Proposal for 271 Madrone avenue

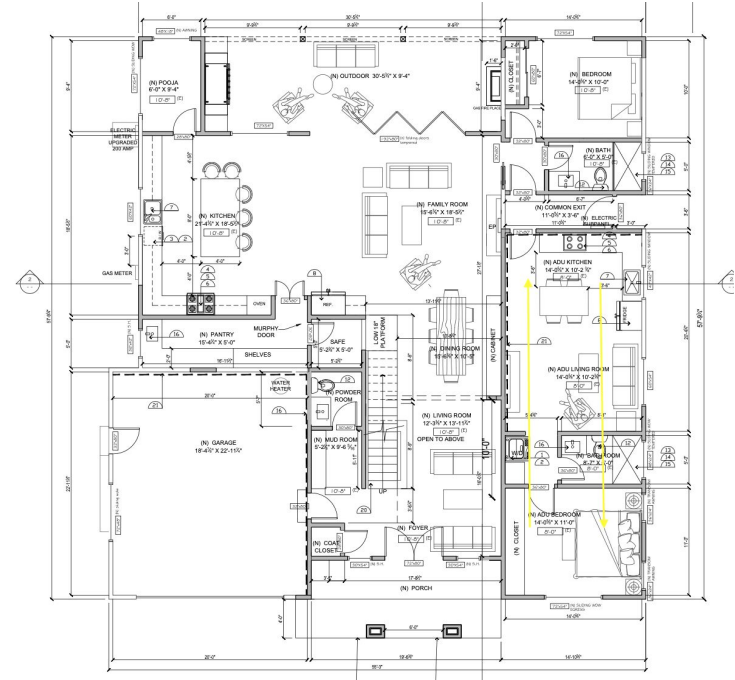
- We discussed with our neighbors on 281 madrone ave and propose to **reduce the height of the bedroom windows** from the earlier 28" to 24" and use **opaque glass to ensure privacy** for both households. The windows in bedroom **provide cross ventilation** and are aligned to the style in the some existing 2 story homes in the neighborhood where the bedroom on the side has a window
- We are open to **removing office window completely** on the other side which is adjacent to 261 Madrone ave.

Propose to remove the office space window in the second floor on the side adjacent to 261 Madrone Ave

Propose to reduce window height to 24" and use frosted/opaque glass for the bedroom and bath windows on second floor on the side adjacent to 281 Madrone Ave

## 5) View from the neighbors house on 261 Madrone Ave

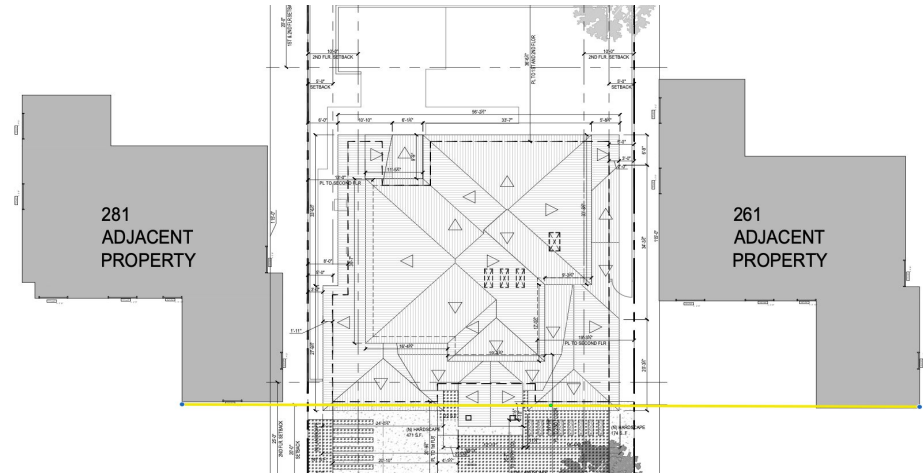
- The frontal lines of the home is **aligned to the garage of the property**.
- The **second floor has** a set back of 10 feet in addition to the 5 feet for first floor, a **total of 15 feet**
- The existing **vegetation and tree provide a natural cover**
- Existing homes with a similar recent construction aligned to the garages of the neighboring homes

## 6) Reduced Open Space and vegetation

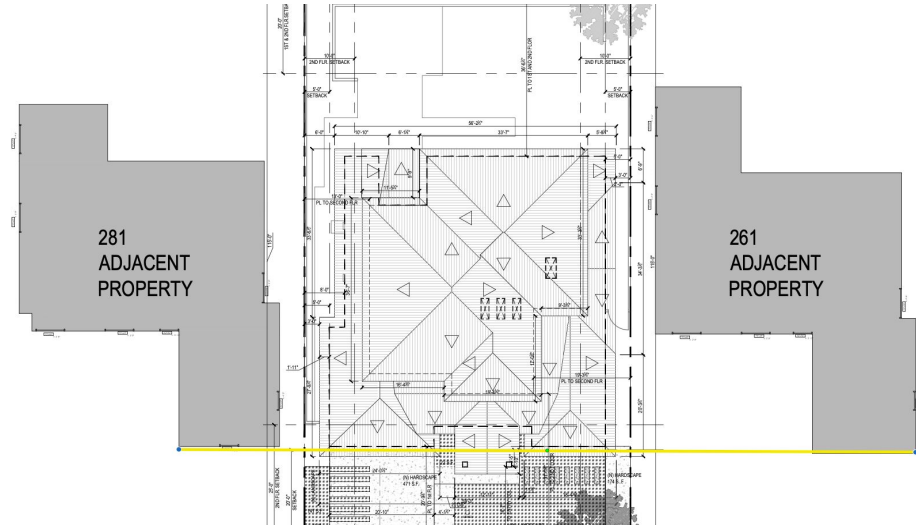
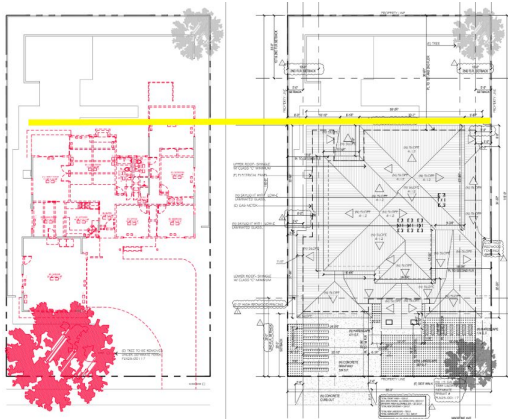
- The **backyard space** of the home is **preserved** when compared to the existing home as highlighted in the picture with yellow lines.
- The **front yard space is aligned** with the **garages of the neighboring homes** and not projecting beyond it.
- While not apparent in the renderings we are committed to adding more landscape and trees in the front and backyard of the home
